**Kiwanis Lodge**  
Richmond Heights, Ohio

ADDENDUM NO. 1

TO THE DRAWINGS AND SPECIFICATIONS FOR:  
Kiwanis Lodge  
**Basement Redevelopment**

**SK-1**

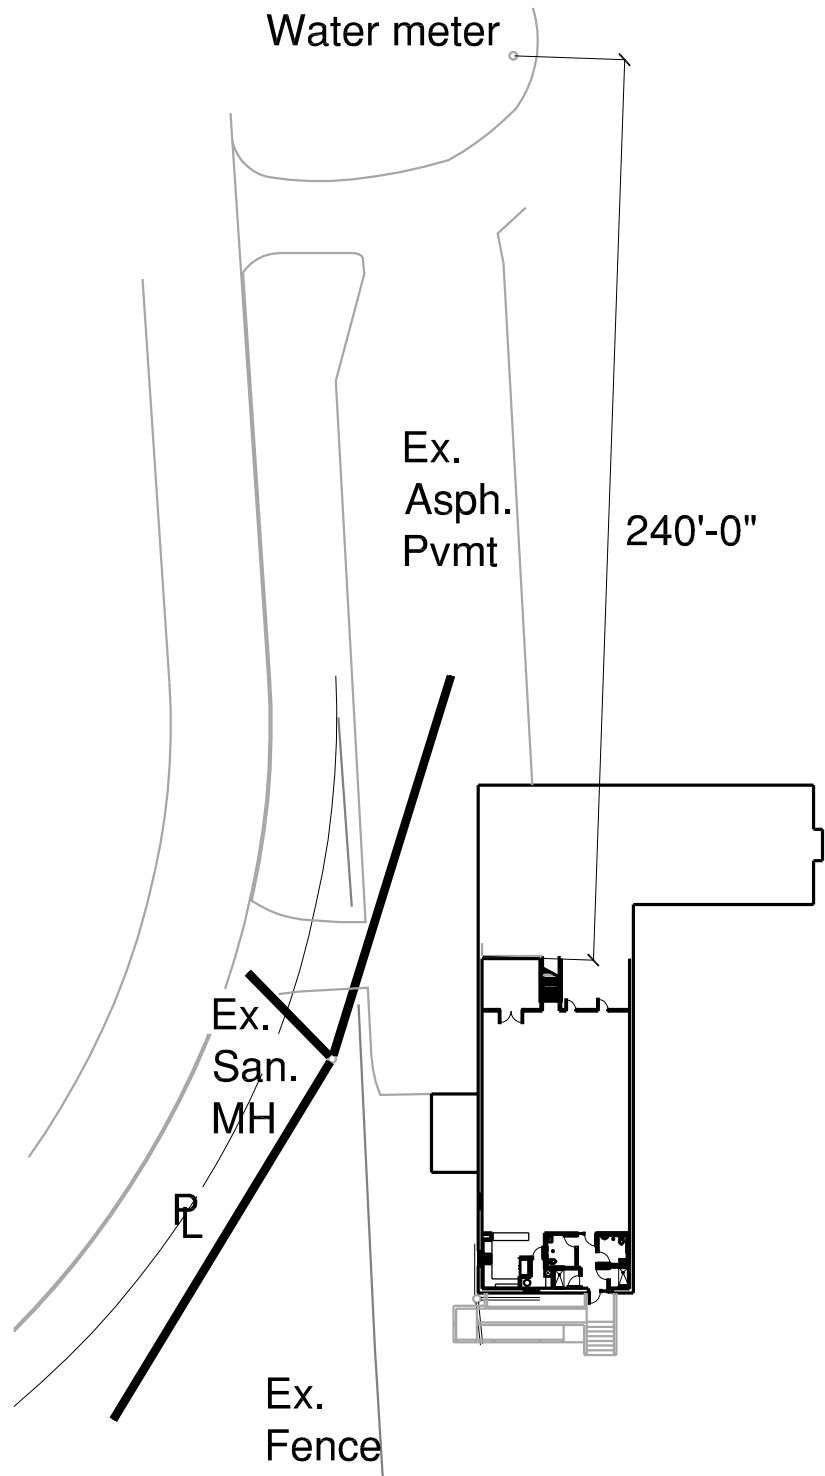
**ITEM 7** Exterior tie-in location for fire suppression system is located at the water meter pit location – see Sketch SK-1.
